SAFETY ORDER

No: SO-P4 091002 1

DOPPELMAYR CTEC SAFETY ALERT BULLETIN SA-08-021 WOLFURT KD08003E

Title: **Tower Failure Due to Water Intrusion**

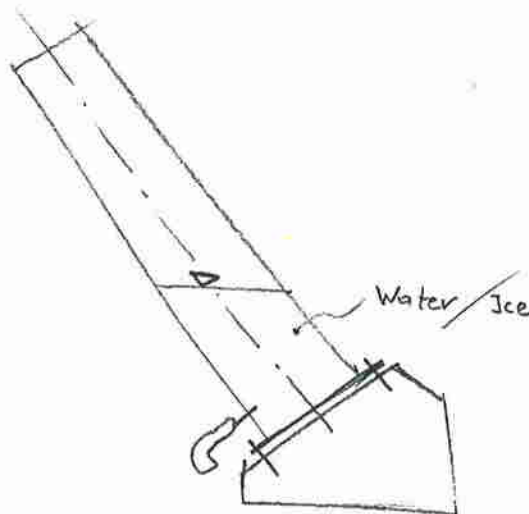
3.1.1 Resonance check: Each tower tube or other hollow structure with a sealed base must be checked for the presence of internal water/ice. When struck with a hammer in several ascending points from the base, a change in the resonating tone of the tower may indicate the presence of water/ice (a tower with water/ice or concrete tends to exhibit a solid "dead" sound compared to a more normal bell-like tone). Some tone differences may be noted due to proximity to base gussets or the presence of internal concrete (see additional information within Section 3.1.2) and will not necessarily indicate the presence of water.

If with a resonance check, water/ice is suspected to be present within the tower but further than 4" (100 mm) from the top plate, a small hole 3/8" - 1/2" (10 - 12 mm) must be drilled near the tower base at the downhill side of the tower along the centerline of the lift 2" to 4" (50 - 100 mm) from the tower base to provide a pathway for water to escape. See illustration below.

3.1.2 Concrete-filled shafts / shaft sections

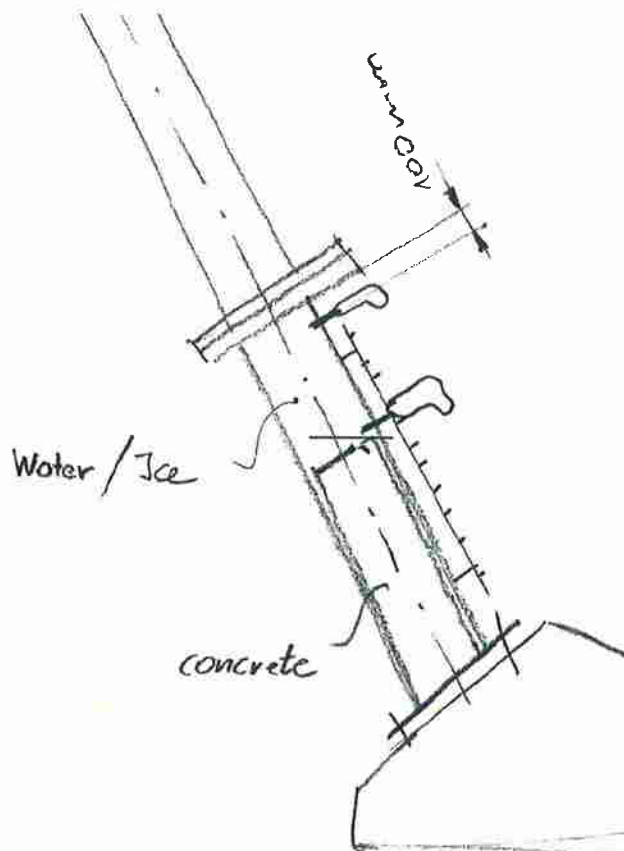
For tower shaft sections partially filled with concrete through the top plate, check the tower section with the hammer method as described previously. If water/ice is suspected, drill a small hole 3/8" - 1/2" (10 - 12 mm) approx. 2 inches (50 mm) below the top plate on the uphill side of the tower (behind the ladder). Tower shafts with a cover for concrete fill on the outside of the shaft already have a drain hole and the cover can be removed for inspection purposes. **If ice is found in this section, this shall be cause for immediate and continued closure of the lift to public transportation** and must be reported to the nearest Doppelmayr representation office for review and recommended repair procedures.

A small drain hole 3/8" - 1/2" (10 - 12 mm) is required to eliminate the water above the concrete level. See illustration below.
